June 27, 2019

**BOARD OF COUNTY COMMISSIONERS  
ORANGE COUNTY, FLORIDA  
IFB NO. Y19-767-TA/ ADDENDUM NO. 2**

**FORCE MAIN SOUTH AREA PACKAGE 2**

SCALE: AS SHOWN  
 DRAWING NO.: **C-201**  
 SHEET: 13 OF 17

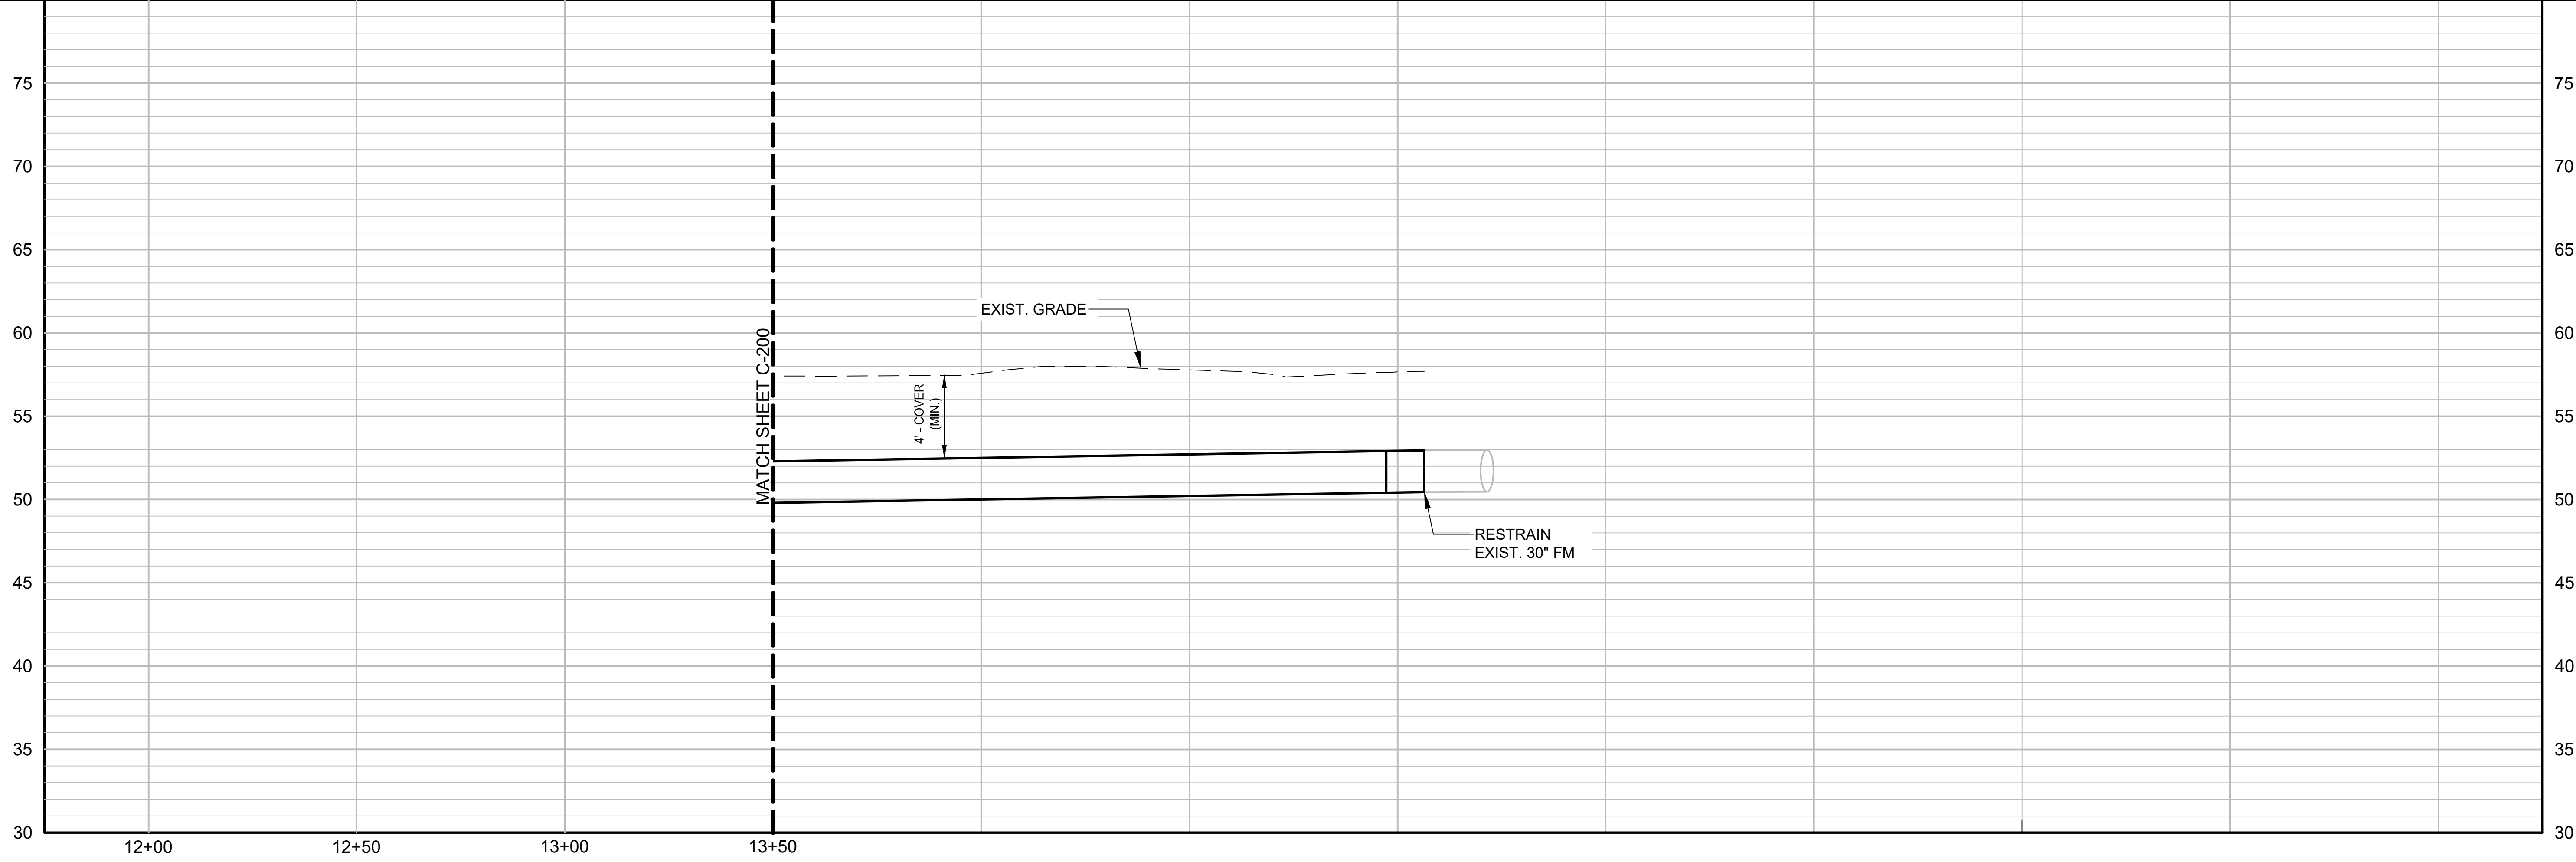
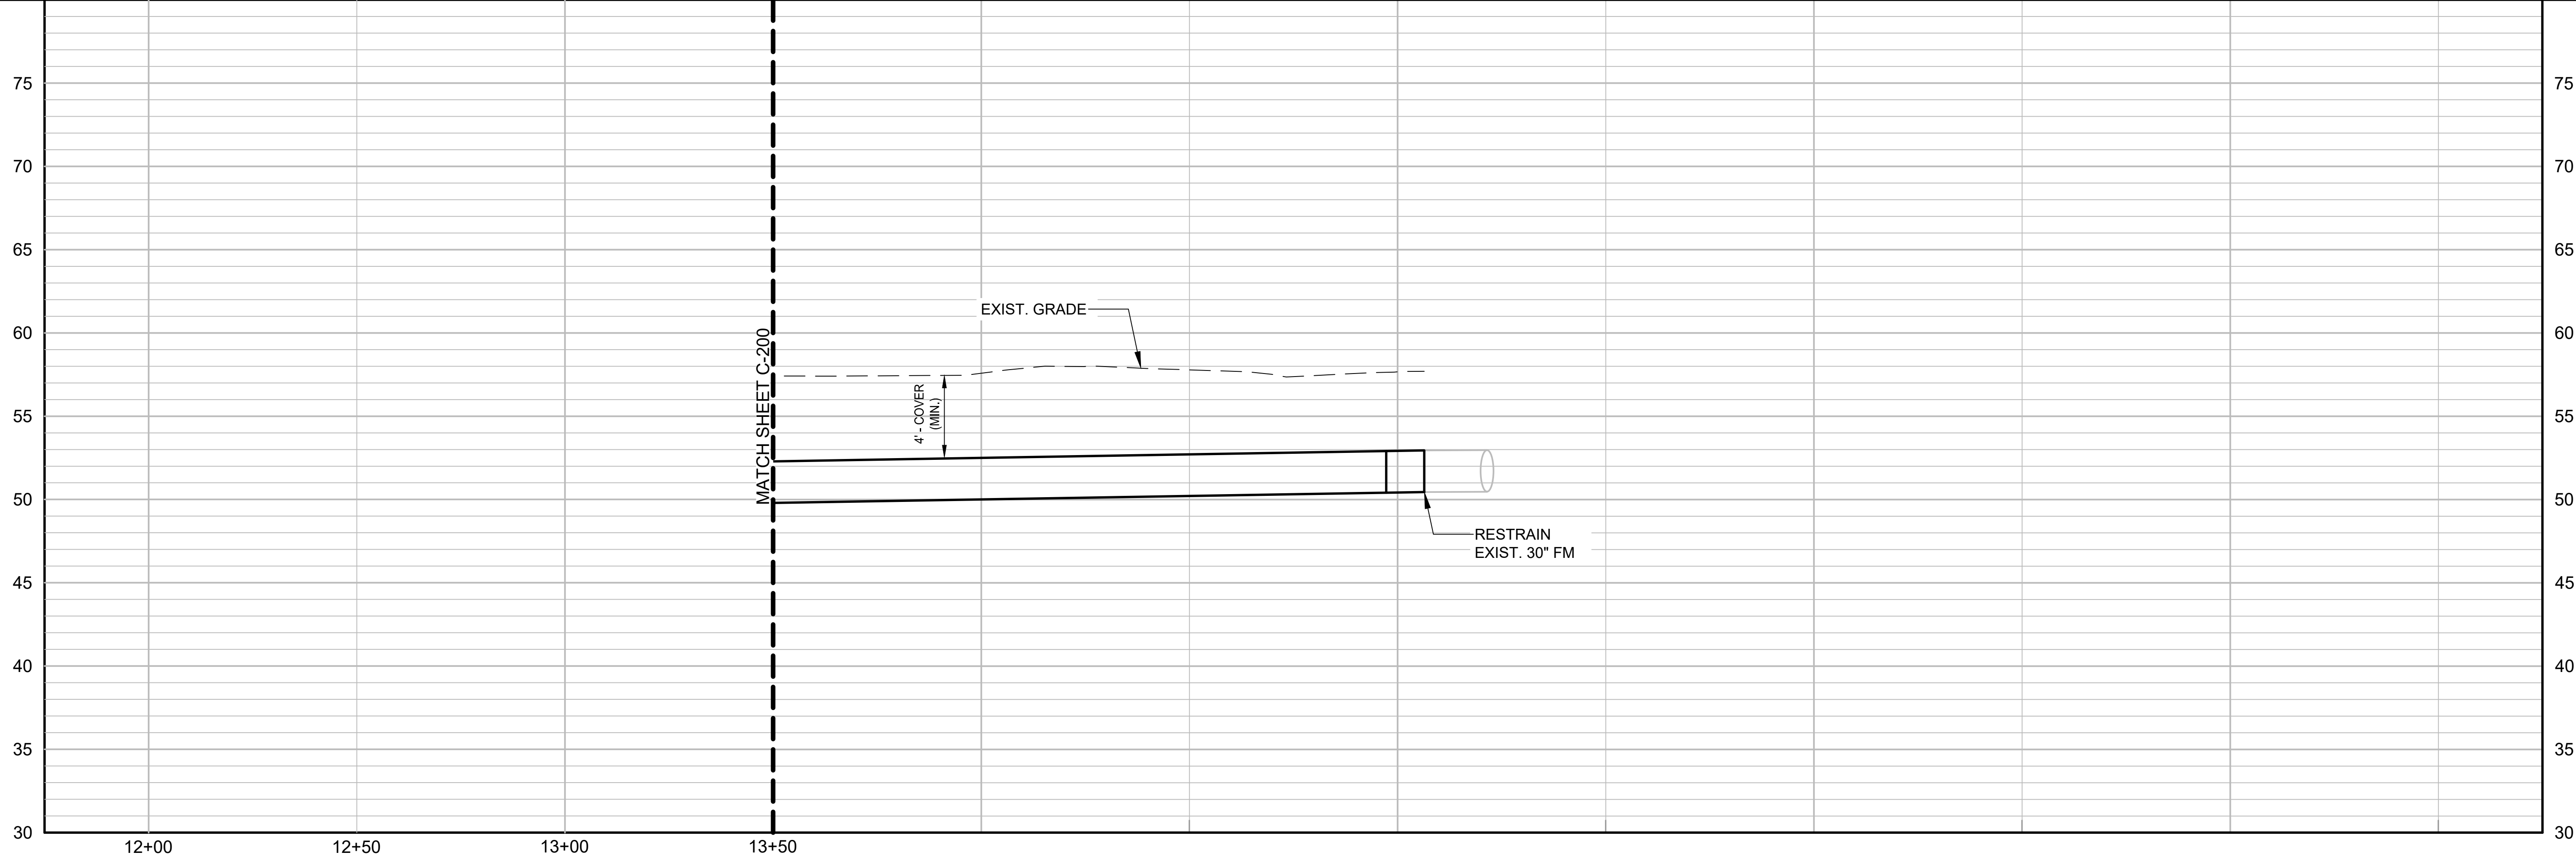
A: Bypass note has been deleted from sheets C100-C102 and C200-C201

- a. **Removal of Bypass note on sheets C-100, C-101, C-102, C-200 and C-201.**
- b. **Revision of ARV size on sheets C-100, C-101 and C-102.**
- c. **Revision of valve size V-13 on sheet X-100.**

OCU FILE NO.: 79645	SCALE: N.T.S.
DESIGNED BY: CHH	DRAWING NO. : X-100
DRAWN BY: EDW	CHECKED BY: SRC
CADD FILE: X-100.dwg	SHEET: 17 OF 17

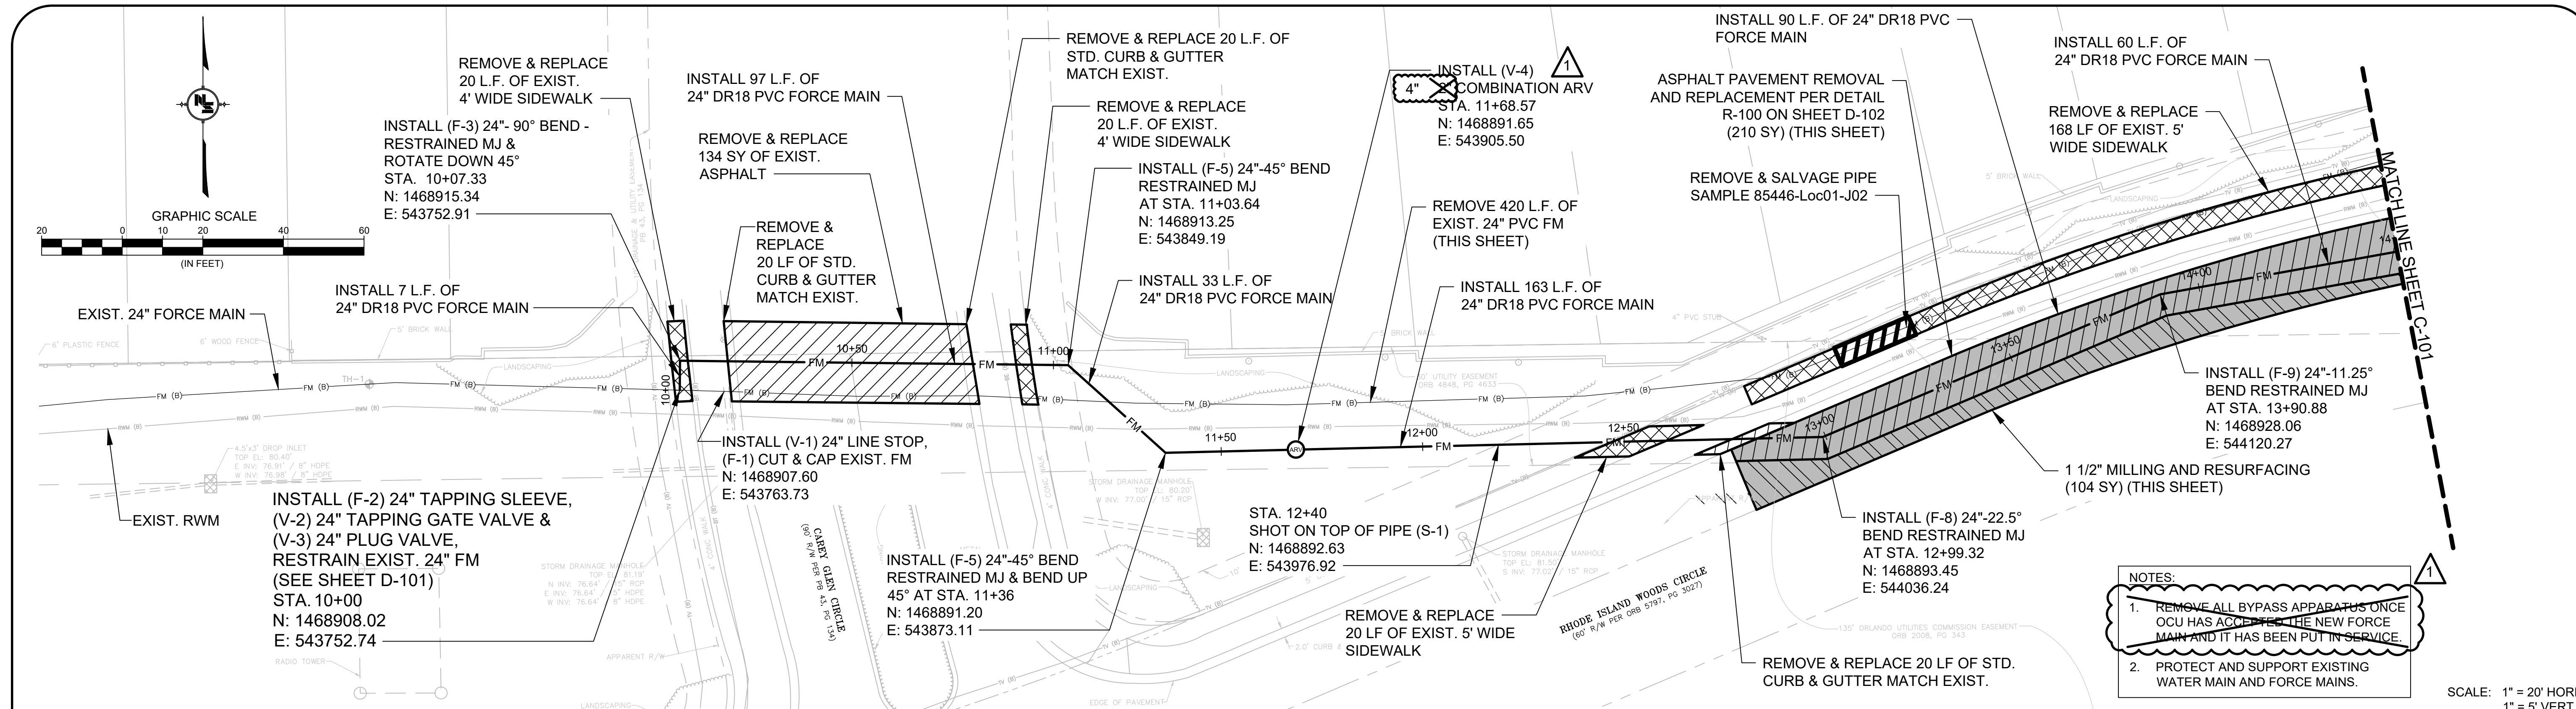
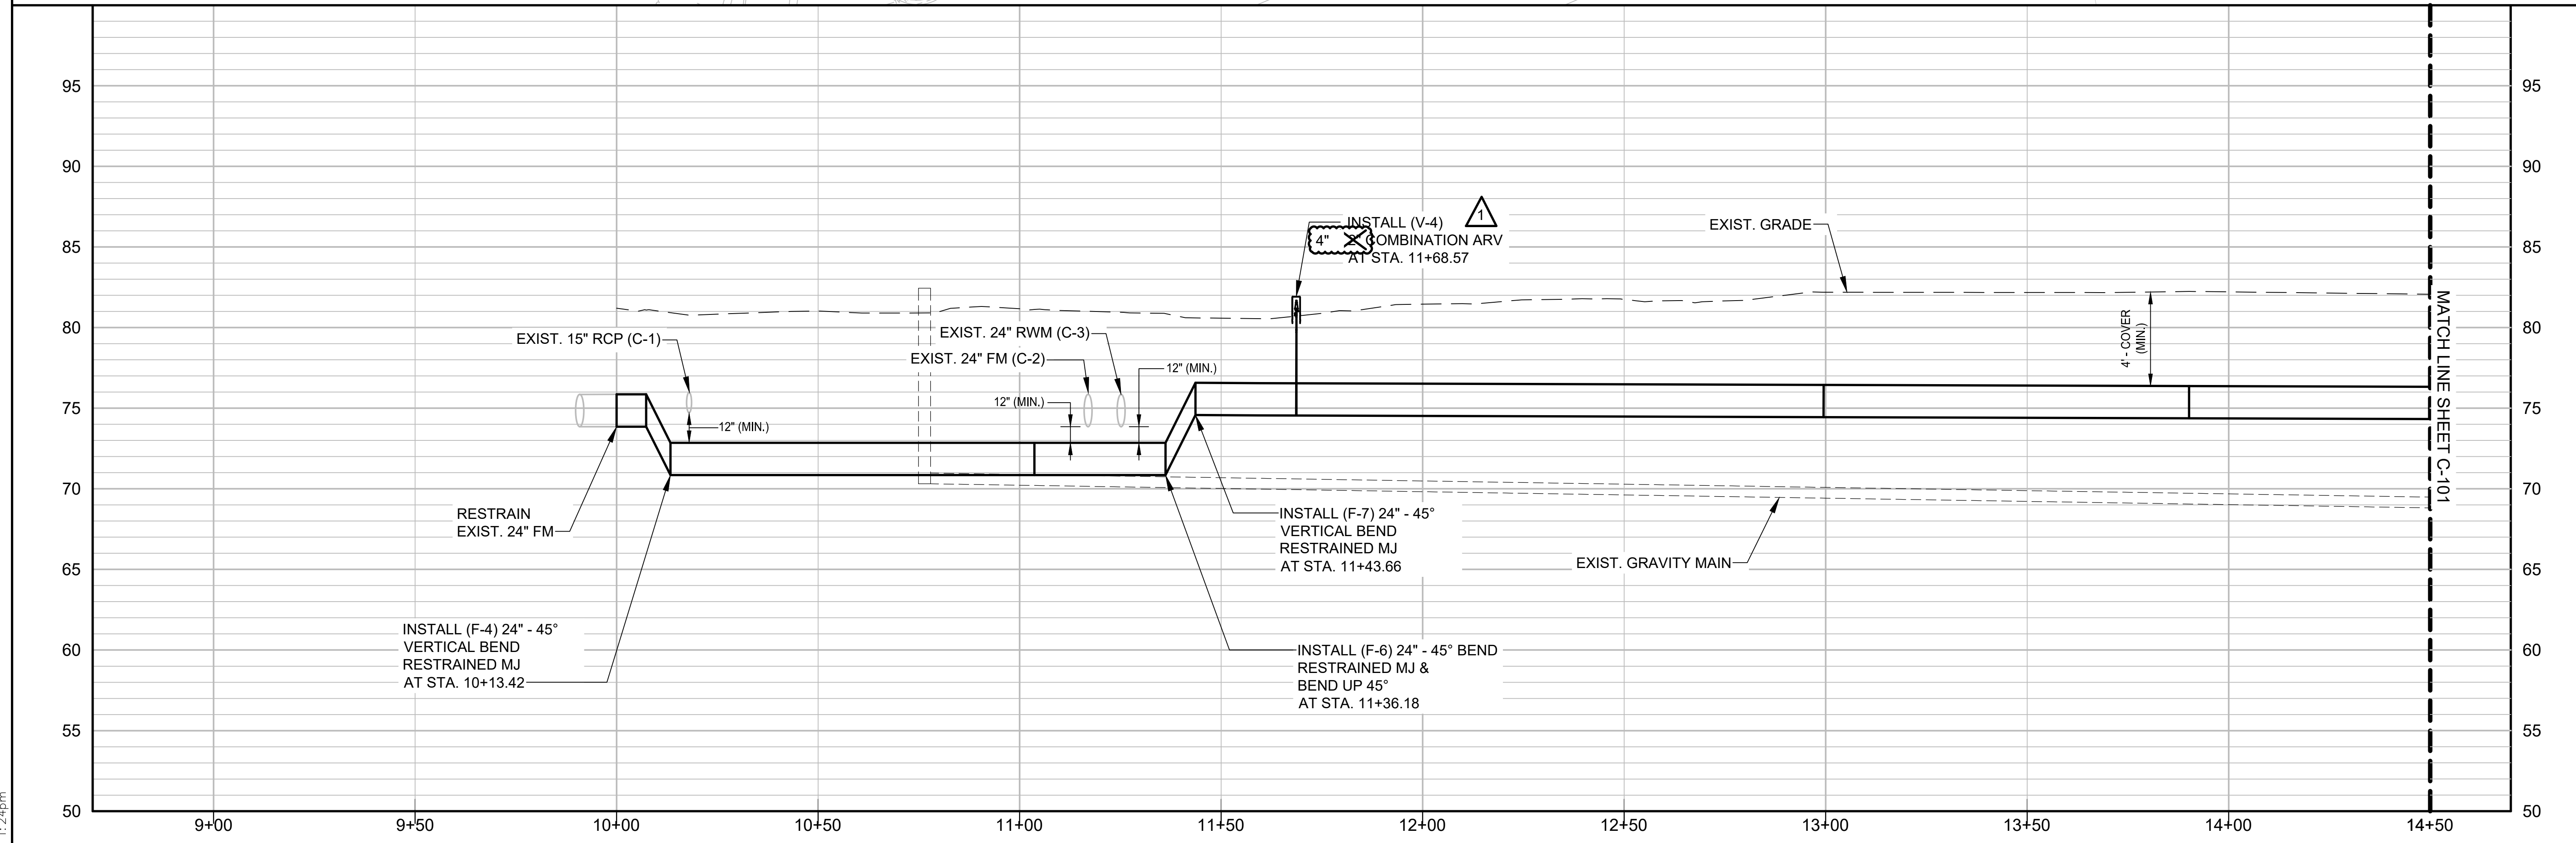
**2. Q: On X-100 Valve V-13 should be identified at 30" not 155.**

A: Sheet X-100 has been revised to show V-13 as a 30".
